S1, S2, S3 VOLTAGE Title: REGULATOR

©Kawasaki Motors Corp 1974 Printed in USA

## NEW VOLTAGE REGULATOR LOT NUMBER

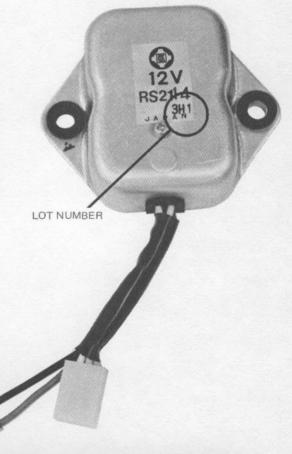
The new voltage regulators (15.0±0.5V) were first manufactured in August, 1973 beginning with the first lot of the month. This information is contained in the lot number 3H1. Any voltage regulator for the S1/S2/S3 manufactured before August, 1973 is the old 16.0±0.5V regulator. The date of manufacture of any voltage regulator can be determined by referring to the following information.
